POINT BEACH NUCLEAR PLANT UNIT NO. 1

Amendment No. 22  
License No. DPR-24

ATTACHMENT TO LICENSE AMENDMENT NO. 22  
TO THE TECHNICAL SPECIFICATIONS  
FACILITY OPERATING LICENSE NO. DPR-24  
DOCKET NO. 50-266

SUPPORTING AMENDMENT NO. 22 TO LICENSE DPR-24

FIGURE 15.3.10-1  
FULL LENGTH ROD INSERTION LIMITS  
POINT BEACH UNITS 1 AND 2

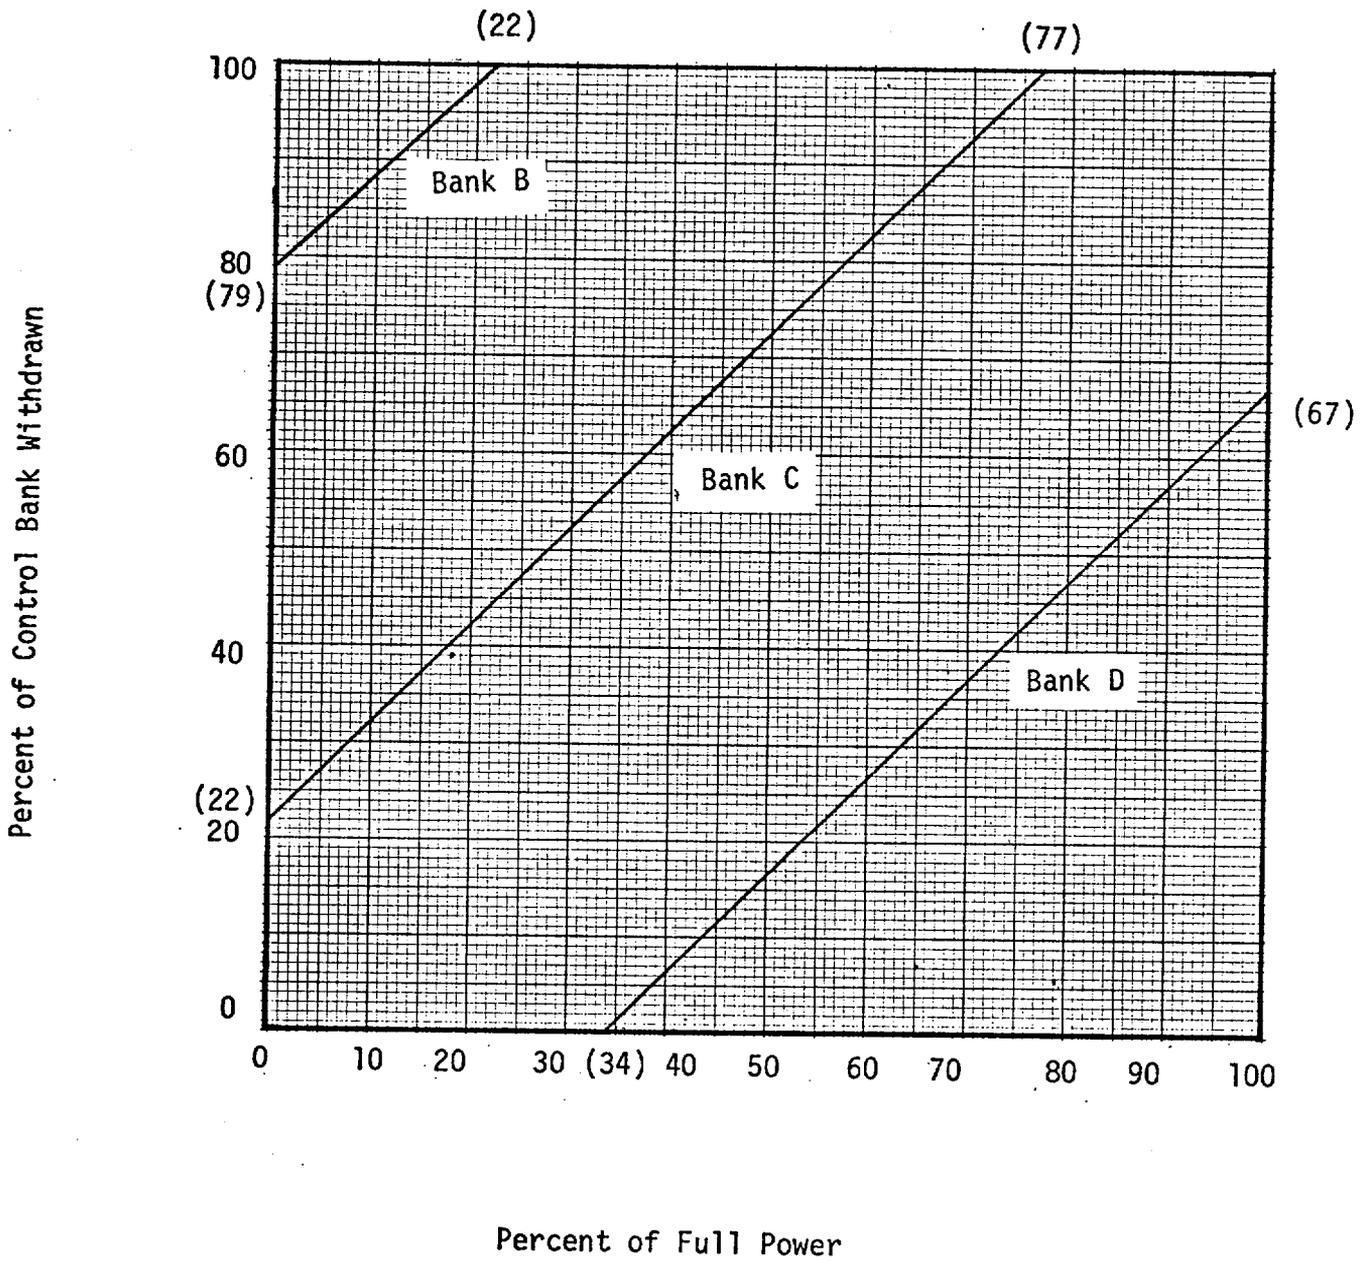
#### (b) Control Rod Insertion Limits and Core Power Distribution Limits (Technical Specification Figures 15.3.10-1 and 3)

The existing Control Rod Insertion Limits and Hot Channel Factor Normalized Operating Envelope apply to core Cycle 4. For core Cycle 5 the licensee has proposed slightly modified rod insertion limits and a modification to the 10.8 to 12 foot elevation line segment in the hot channel normalized operating envelope. Based on our review of the information supplied by the licensee and the reanalysis of the rod ejection accidents discussed above, we have concluded that the proposed changes are acceptable.
